First Revision No. 8644-NFPA 70-2018 [Detail]

REVISE TITLE OF SECTION 690.15 FROM:
Disconnection of Photovoltaic Equipment.
TO
Disconnecting Means for Isolating Photovoltaic Equipment.

Figure Informational Note Figure 690.1(a) Identification of PV Power Source Components.

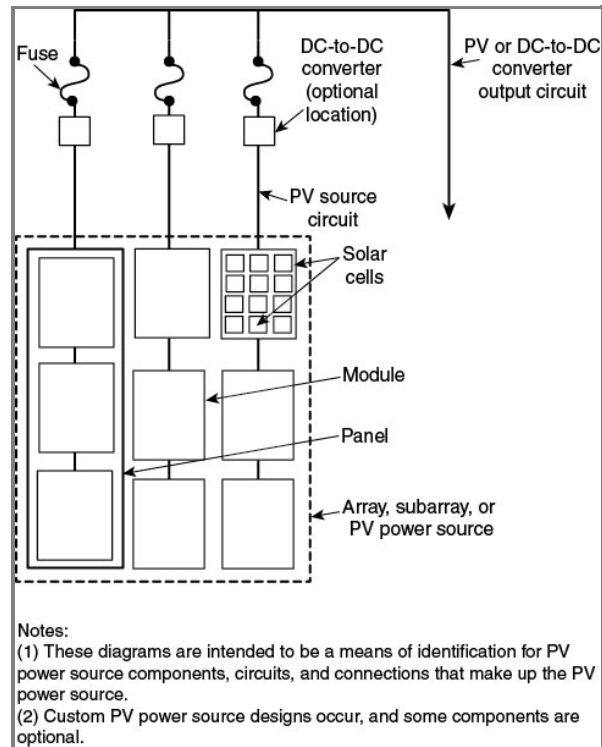
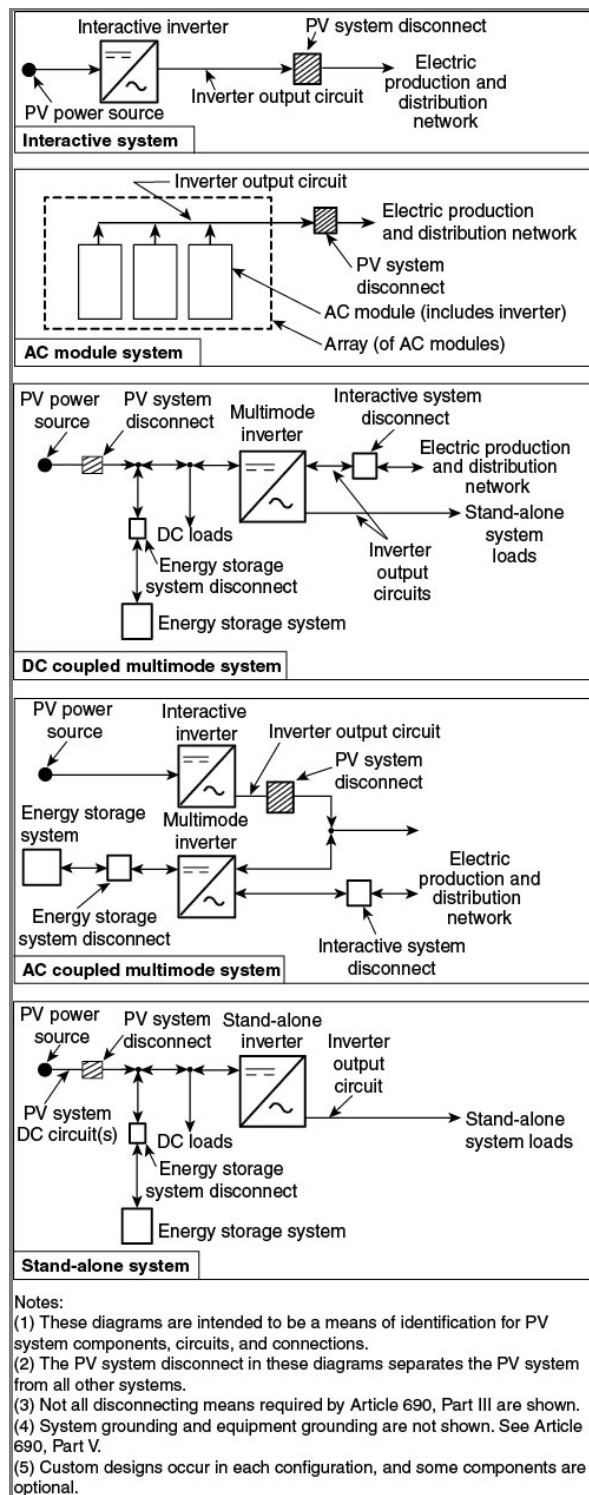
This article applies to solar PV systems, other than those covered by Article 691, including the array circuit(s), inverter(s), and controller(s) for such systems. ~~[See Figure 690.1(a) and Figure 690.1(b) .]~~ The systems covered by this article ~~may be include those~~ interactive with other ~~electrical electric~~ power production sources or stand-alone, or both, ~~and may or may not be connected to energy storage systems such as batteries~~ . These PV systems may have ac or dc output for utilization.

Informational Note No. 1: See Informational Note Figure 690.1(a) and Informational Note Figure 690.1(b).

These particular figures have been changed to informational notes since they are intended for informational purposes only and are not meant to dictate design standards or configurations. The terms in the figures were revised for consistency throughout articles under the purview of CMP-4.

Figure 690.56(C) Label for ~~Roof-Mounted PV Systems that Shut Down the Array and the Conductors Leaving the Array .~~

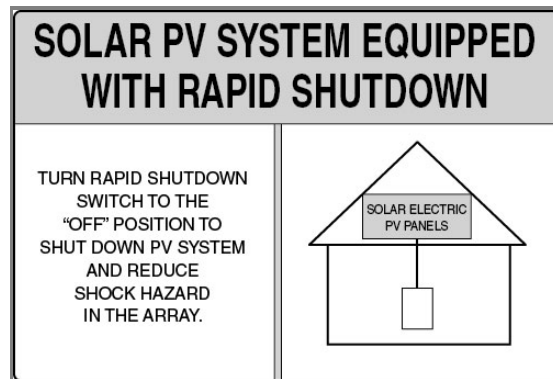
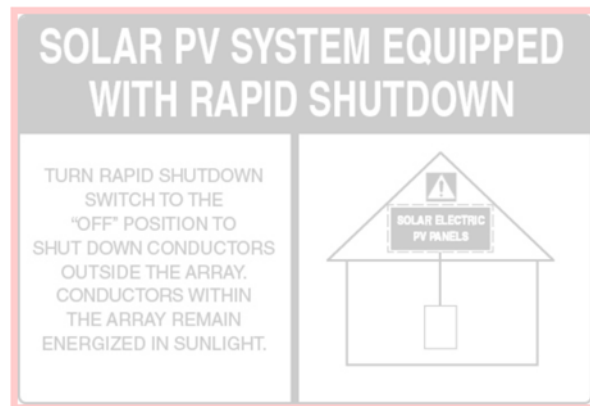
Committee Statement: Several changes are made to the existing language in 690.56(C) to address the updated requirements in 690.12 that no longer provide a delayed enforcement date for 690.12(B)(2).

In several places the existing language has been rearranged and updated to provide improved clarity. Additionally 690.12(C)(1) has been changed to remove the option for the label, previously listed under 690.56(C)(1)(b), since this label now describes a shutdown method that is no longer Code compliant.

The title of the figure has been changed to identify this figure as an informational note to clarify that the label as shown is merely an example of a rapid shutdown system label. Other label arrangements and/or diagrams are acceptable.

<u>Date</u>	<u>Submitted By</u>
Jan 18, 2018	NEC-CMP Panel 04 Figure 690.56(C)(1)(b) is being deleted through this revision.

Figure Informational Note Figure 691.1 Identification of Large Scale PV Electric Supply Station Components.**Supplemental Information**

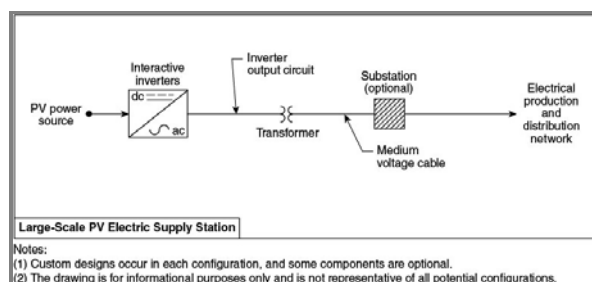
The new Informational Note No. 3 figure will help in identification of unique system components related to large scale PV electrical supply stations that are not otherwise covered in the Informational Note

Figures 690.1(a) and 690.1(b). This drawing is meant as an aid in interpretation.
